<p>شماره سند:</p> <p>No:</p>	<p>TES/2020/W-003</p>	
<p>پروژه:</p> <p>Project:</p>	<p>Design and Build of Gdh. Faresmaathoda Airport</p>	
<p>تاریخ صدور:</p> <p>Issued Date</p>	<p>February 24, 2020</p>	
<p>تعداد صفحات:</p> <p>No. of Pages: -1</p>	<p>تعداد برآوردها:</p> <p>BoQ: -01</p>	<p>تعداد نقشه‌ها:</p> <p>Drawings: -00</p>

*TES/2020/W-003- CLARIFICATION 1- Design and Build of Gdh. Faresmaathodaa
Airport*

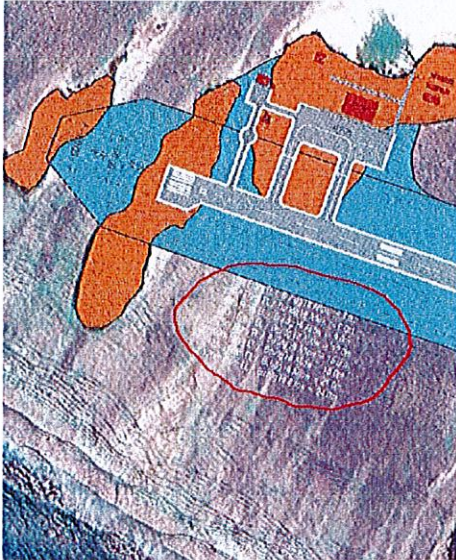
27. The highlighted area in the below drawing the measurements are not clear to read

A clear drawing is included in the Employer's Requirement.
